**Regular Meeting**  
**Planning & Zoning Board**

**1. P.H. 2026-030: APPLICATION 83-B1-11 Rev.8**

# Development Review Committee Summary Report Development Plan Application Review

<b>Project Name:</b>	Fifth Third Bank	<b>Application No.:</b>	83-B1-11 Rev. 8
<b>Reviewer Name:</b>	Daniel Mantell	<b>Project Address:</b>	3701 W Hillsboro Blvd
<b>Department/Division:</b>	Planning & Development Services		
<b>Position:</b>	Planning & Zoning Manager		
<b>Date of Review:</b>	1-16-2026		
<b>Submittal No.:</b>	5

OVERALL EXISTING VEGETATION PLAN  
SCALE: 1" = 30'  
DATE: 5.27.2025  
SHEET: LA1-00

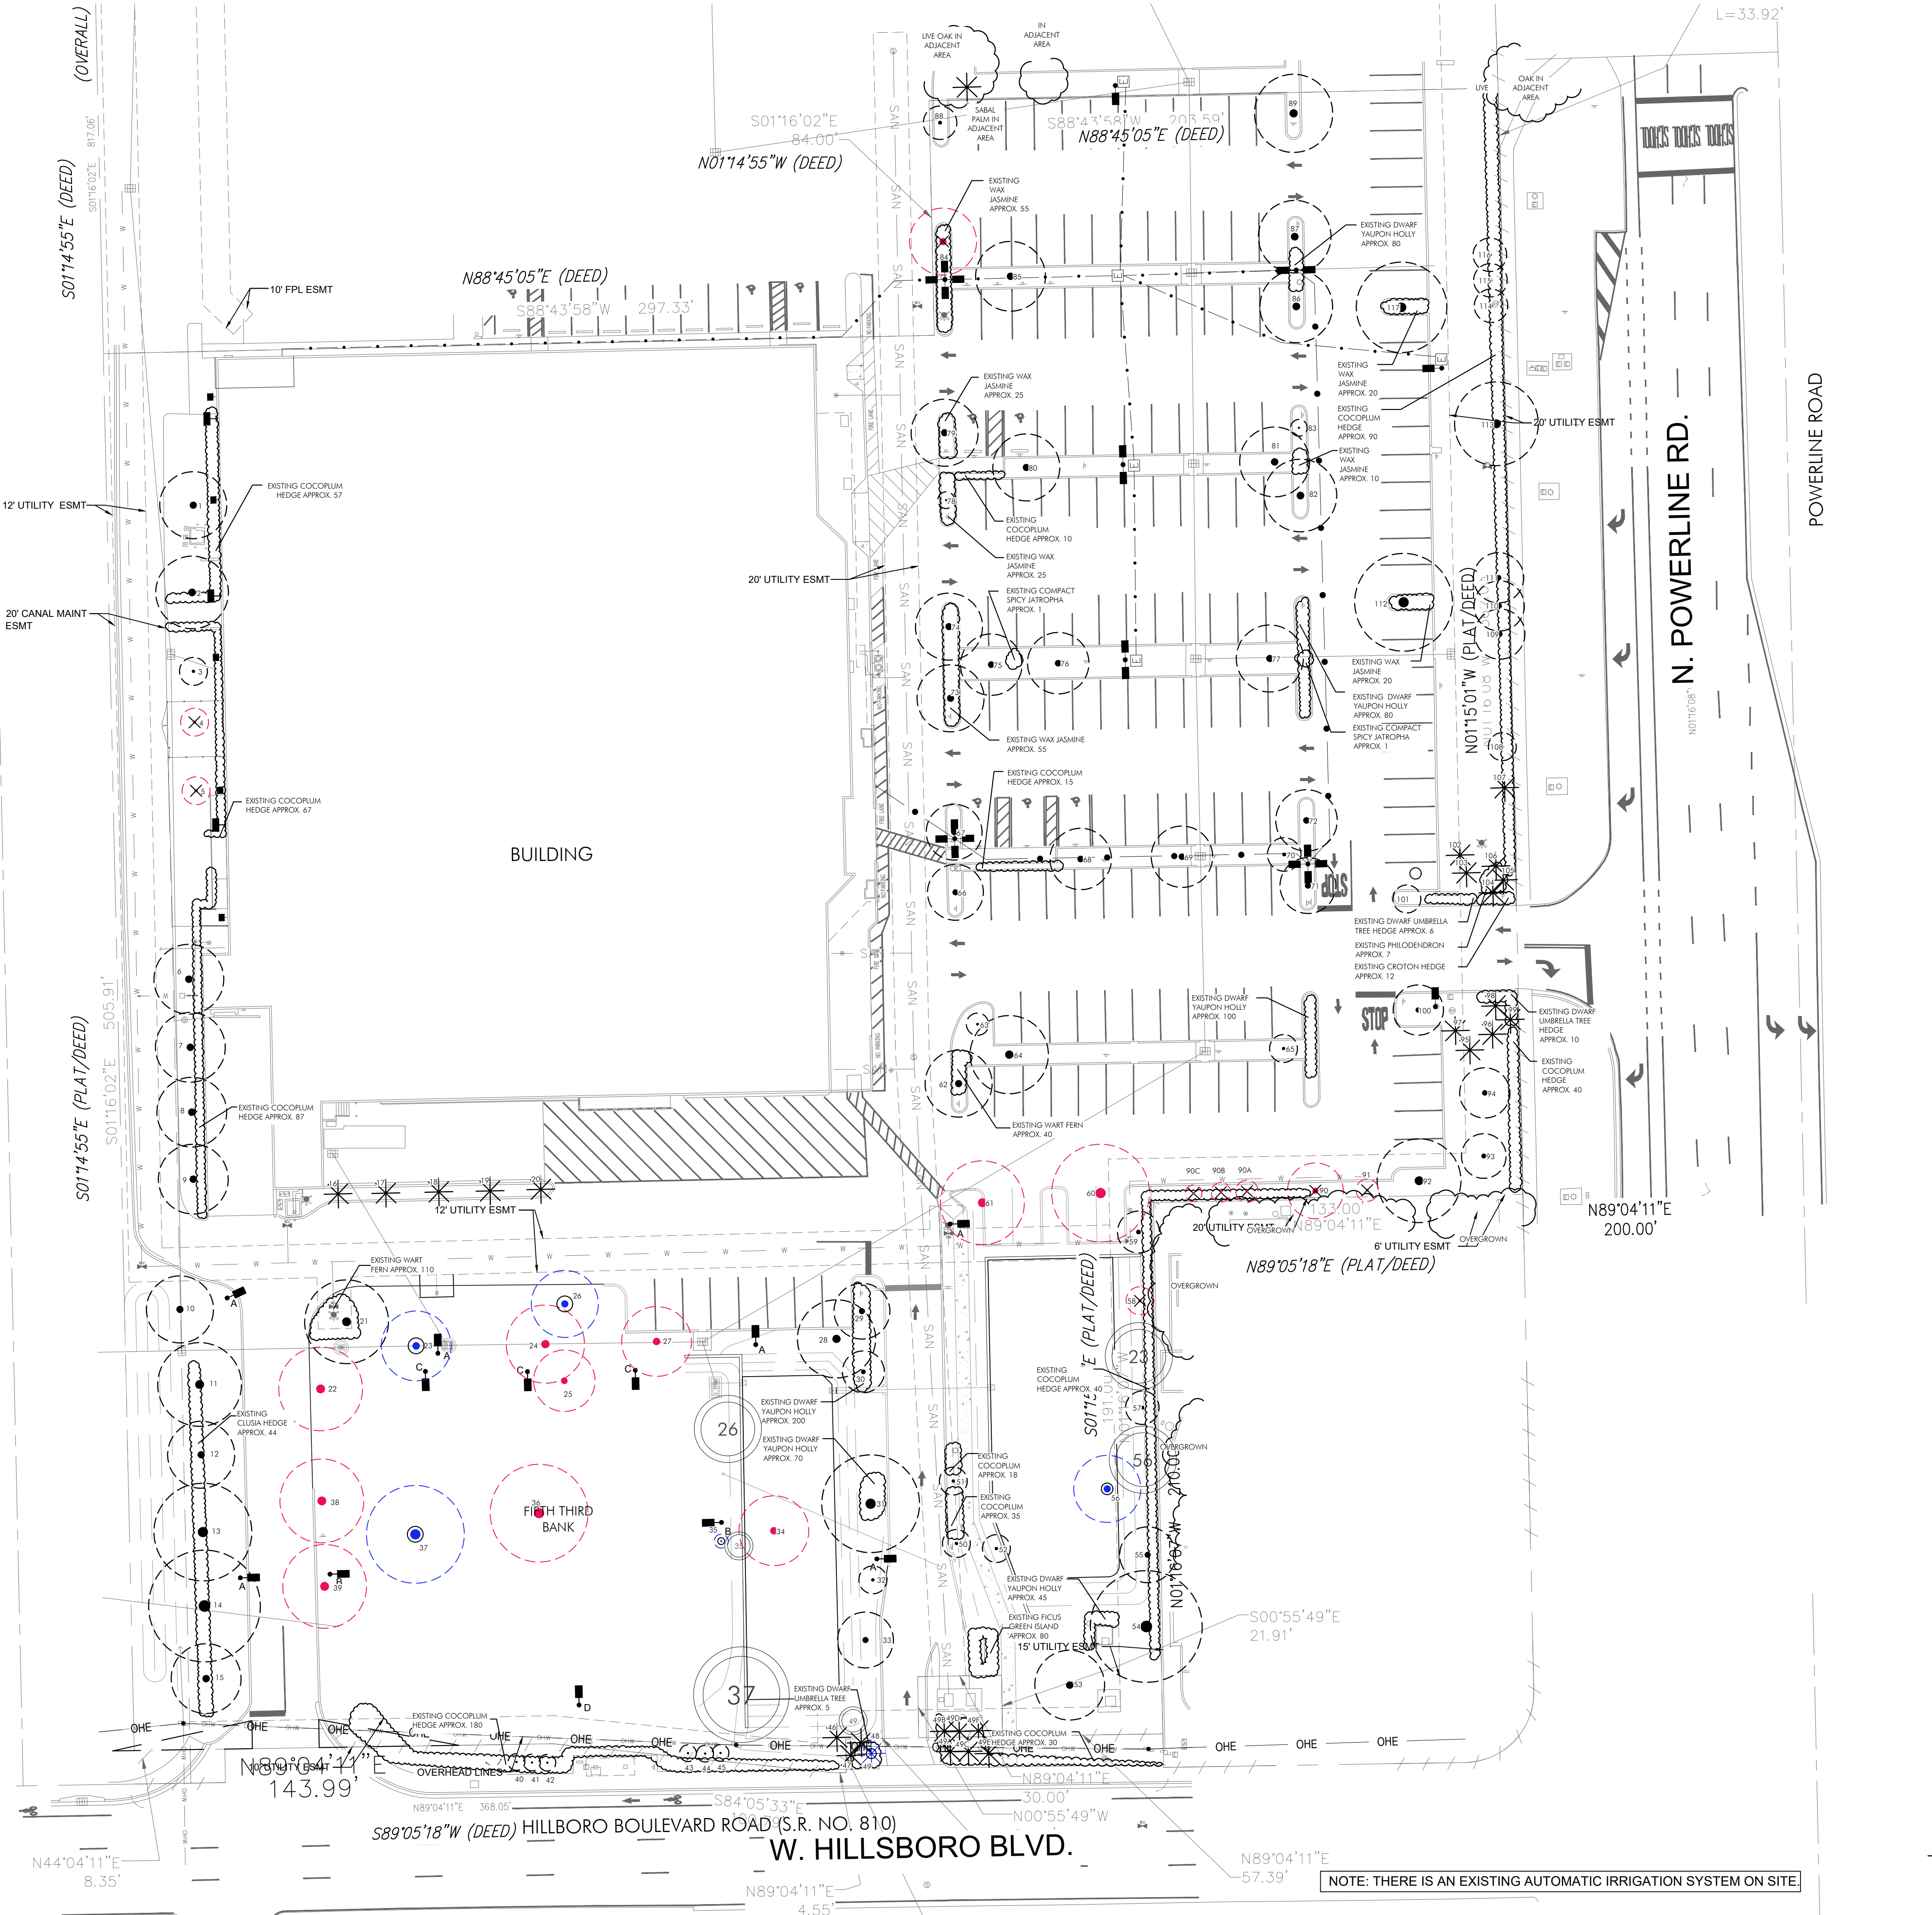
<b>A.</b>	<b>LANDSCAPE PLAN:</b>
1.	The submitted site and landscape plans are part of a larger site, as shown on sheet LA2-00. Add note "Existing plant material outside of project impact area to remain undisturbed".

NOTES:  
-THERE IS AN EXISTING AUTOMATIC IRRIGATION SYSTEM ON SITE.  
-EXISTING PLANT MATERIAL OUTSIDE OF THE PROJECT IMPACT AREA IS TO REMAIN UNDISTURBED.
